**1.2 1221-1249 CENTRE ROAD, OAKLEIGH SOUTH
USE AND DEVELOPMENT OF THE LAND FOR PRELOADING OF EARTH AND
CONSTRUCTION OF BUILDINGS AND WORKS (TEMPORARY LANDFILL GAS
VENTING TRENCH) AND ALTERATION OF ACCESS TO A TRANSPORT ZONE, 2
(TPA/53179)**

EXECUTIVE SUMMARY:

This application proposes further remediation and rehabilitation works on the site of the former Talbot Road Quarry. Ground improvement works (pre-loading) and a temporary landfill gas venting trench are proposed in the north west corner of the site.

LEGEND			
	INFERRED PIT BATTER (APPROX.)		STOCKPILE FILL LEVEL
	FINAL SITE LEVEL (APPROX.)		EXISTING GROUND LEVEL

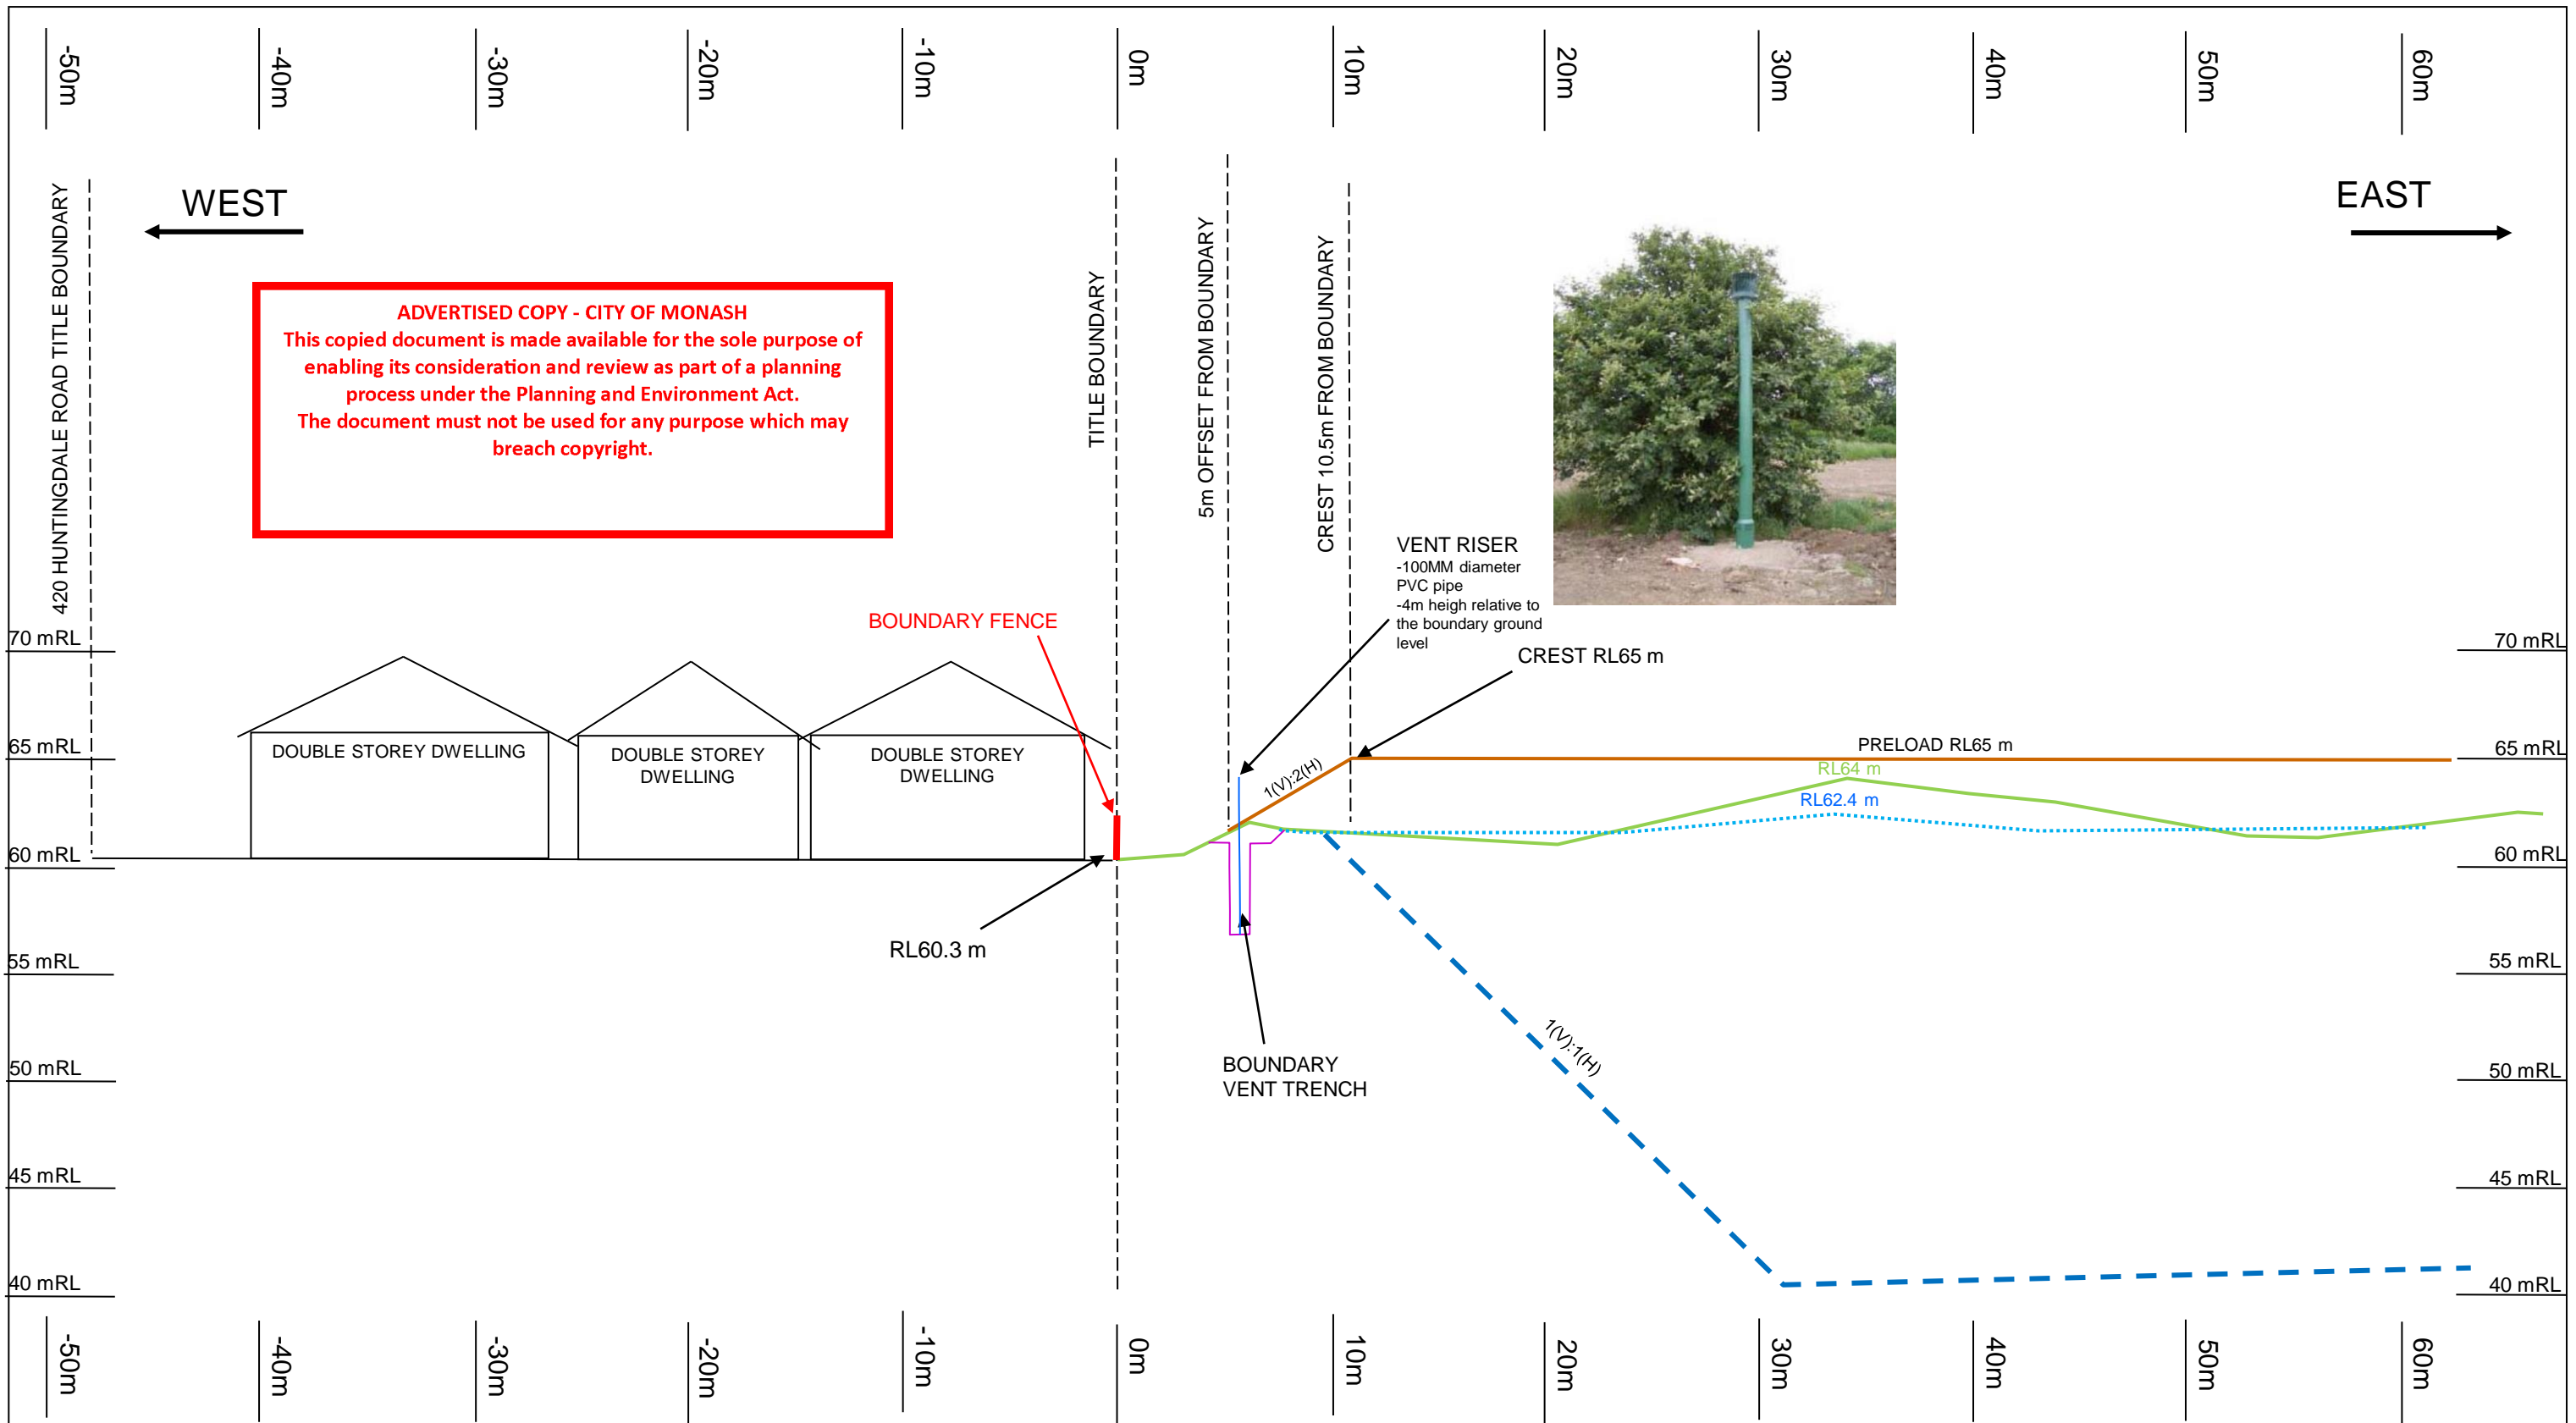
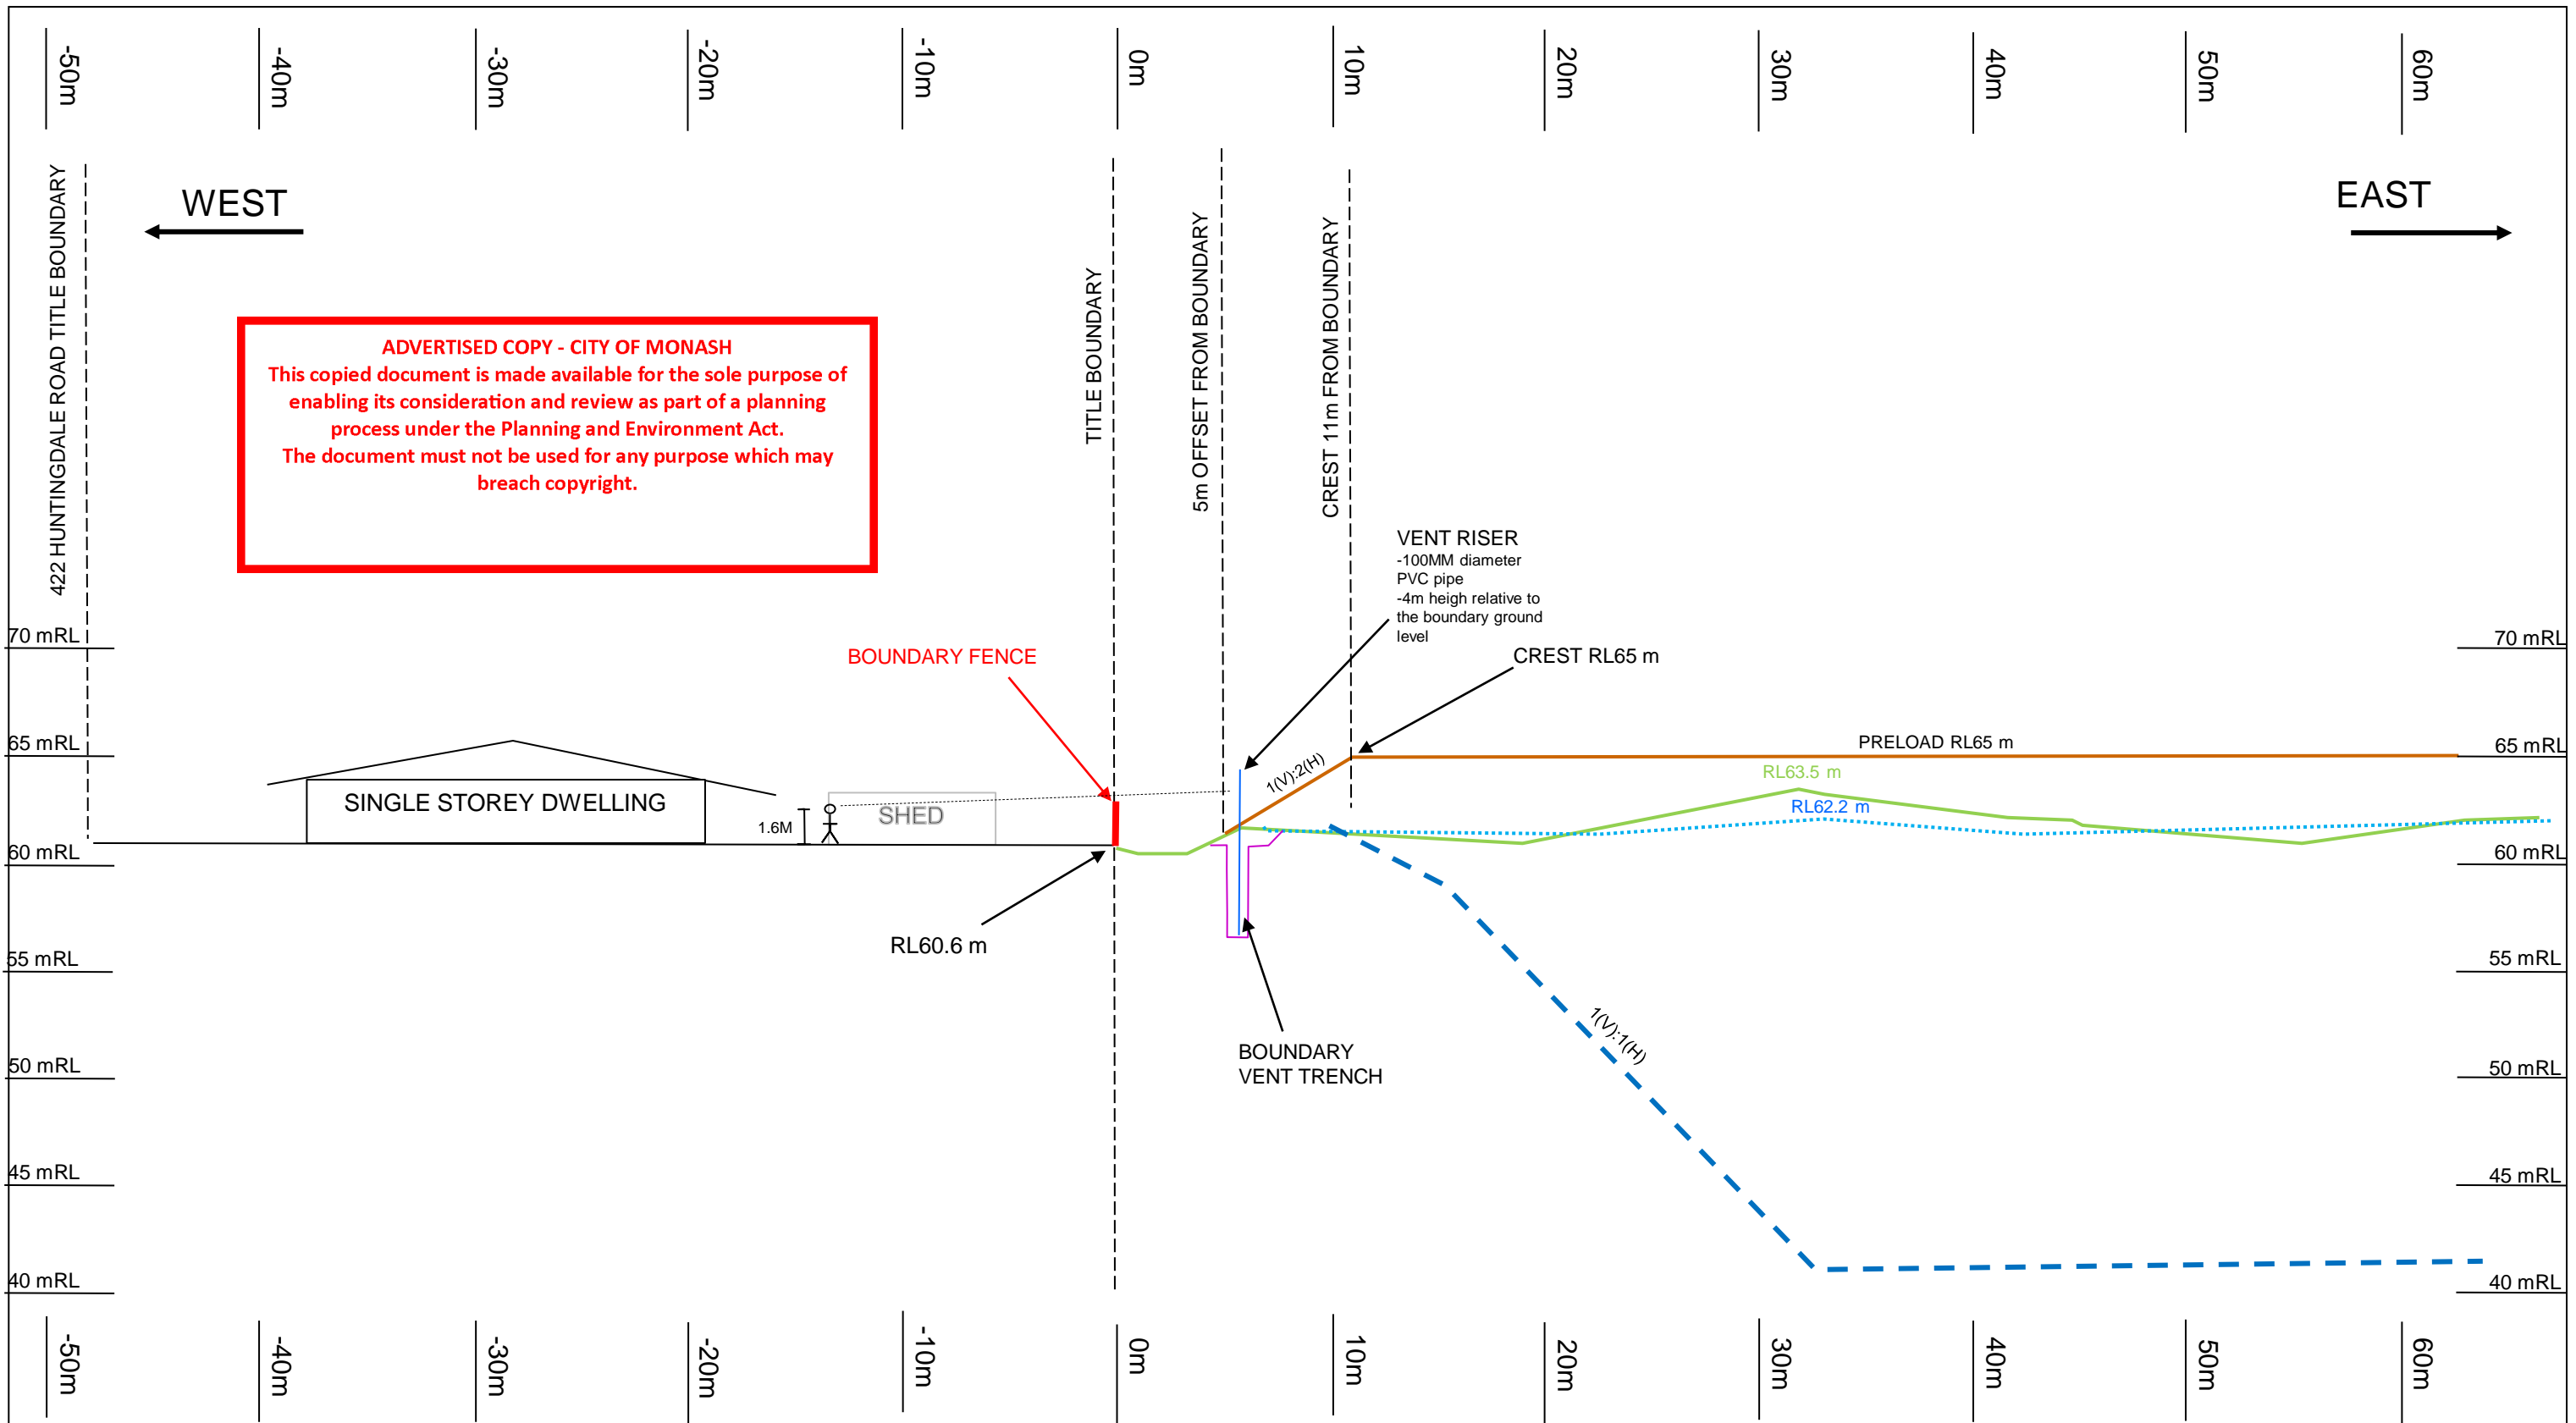
- a) The location and height of the proposed silt fencing to be shown on sectional diagrams prepared by Tetra Tech Coffey.
 - b) The location and minimum setbacks of the proposed swale drain to adjoining properties and identified on sectional diagrams on the plans prepared by Tetra Tech Coffey.

- Concern is raised with the slope of the batter in relation to the proximity of the boundaries and the interface with the residential properties. This will need to provide for a more gradual and gentle slope.

- The preload has been designed with a 5m buffer from the site boundary to the toe of preload batter. This enables the crest/top of the preload to extend to the edge of the pit crest to provide a uniform surcharge over the landfill to reduce subsequent total and differential settlement of the landfill capping layer and structural fill layers.

TITLE:
 SITE ENVIRONMENTAL
 MANAGEMENT PLAN

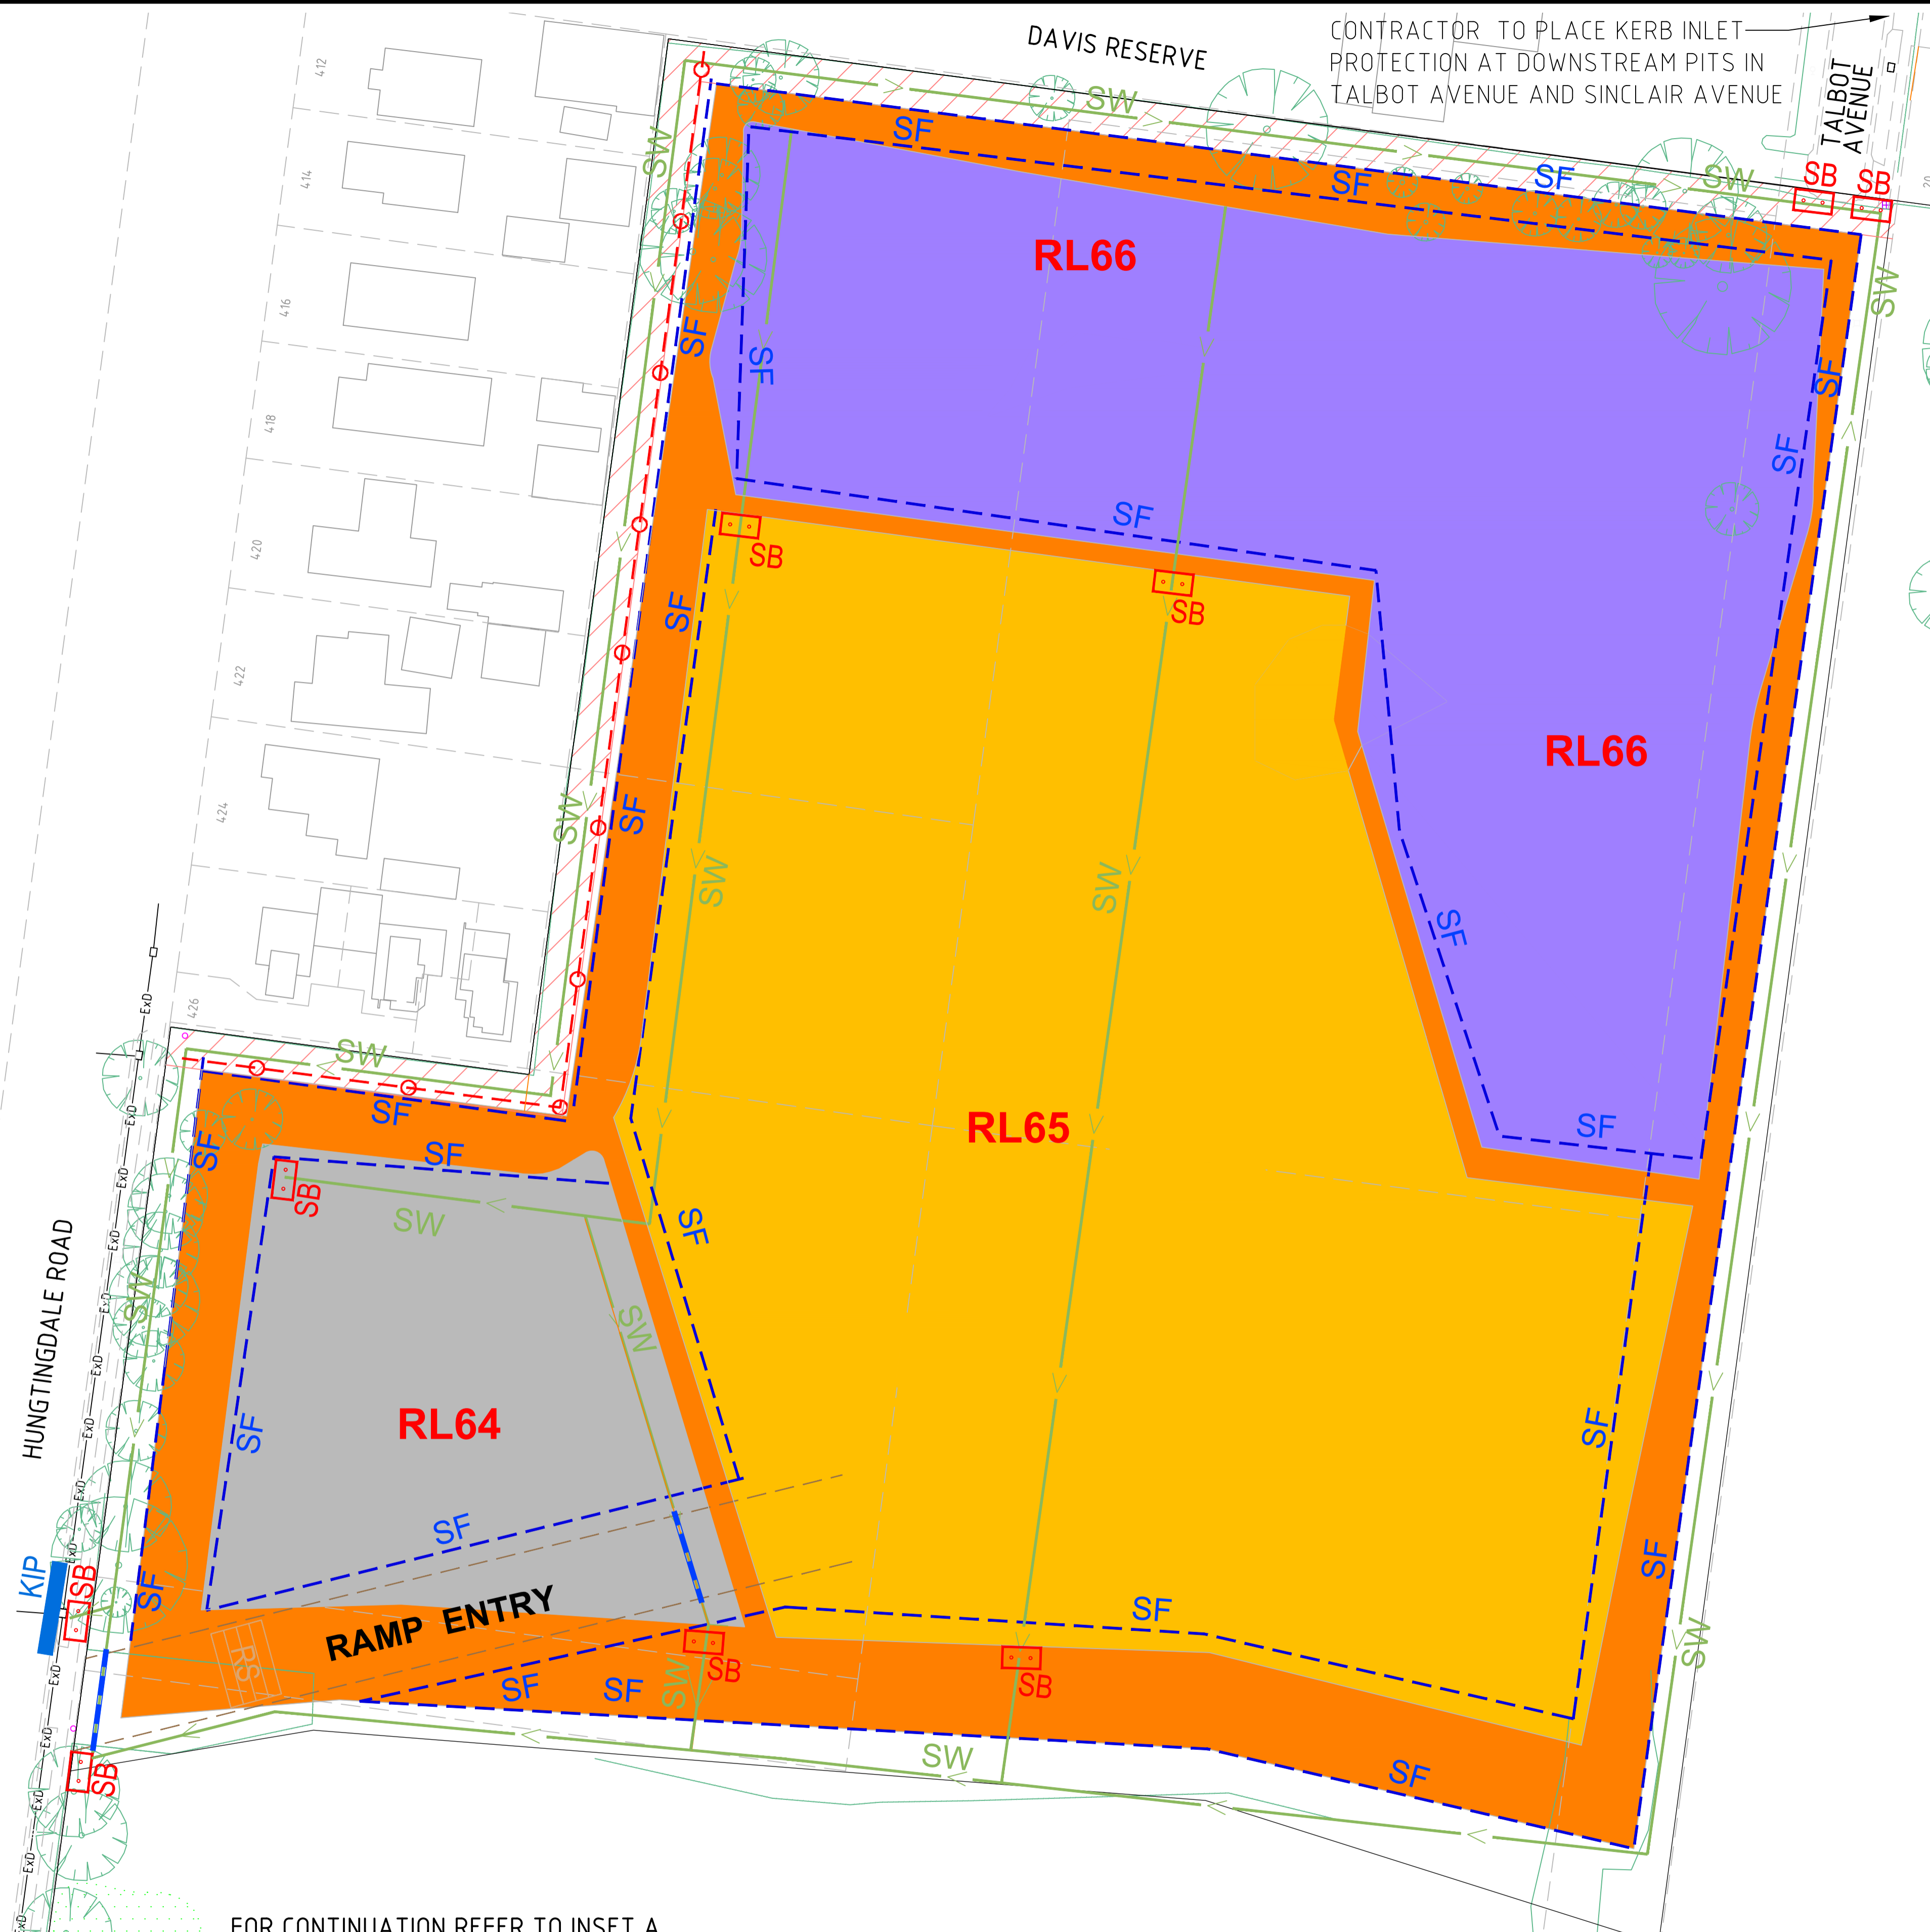
- c) The location of the crest of the sand quarry pits in relation to the property boundaries to be shown on the Site Environmental Management Plan prepared by Verve, dated 28 September 2021;
